COMMUNITY DEVELOPMENT  
DEPARTMENT REPORT

HEARING DATE: 3/5/2026  
TO: Planning & Zoning Commission  
FROM: Nick Napoli, Associate Planner  
208-884-5533  
nnapoli@meridiancity.org

SUBJECT: H-2025-0052 and ZOA-2025-0002  
VanTrust

LOCATION: Generally located at the southwest corner of Black Cat Road and Franklin Road in the NE ¼ of the NE ¼ of Section 16, T.3N., R.1W.

### E. Building Elevations (date: 11/4/2025)

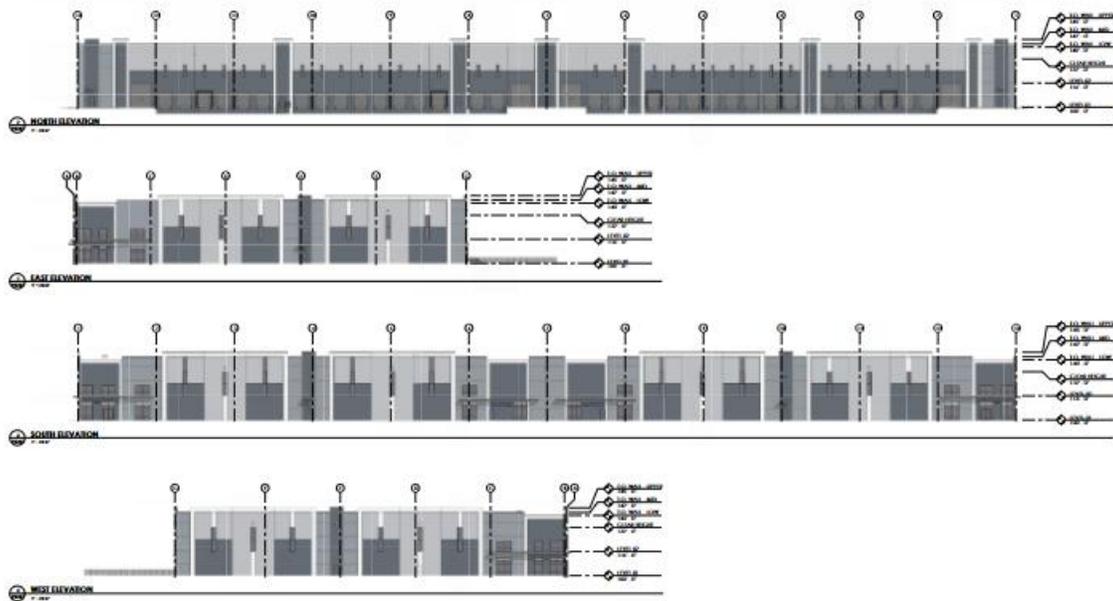
The Architectural Standards Manual (ASM) and TMISAP require surface plane modulation at intervals of no more than 50 feet, the inclusion of at least two pedestrian-scale architectural features, and a combination of at least two primary field materials and one accent material.

The applicant proposes six (6) one-story industrial buildings designed with high ceilings. The exterior materials include tilt up concrete, glazing, and metal awnings. However, it does not appear that the applicant meets the requirement for 30% glazing along public streets.

If approved, the final elevations will be evaluated during the design review process to ensure compliance with industrial design standards.
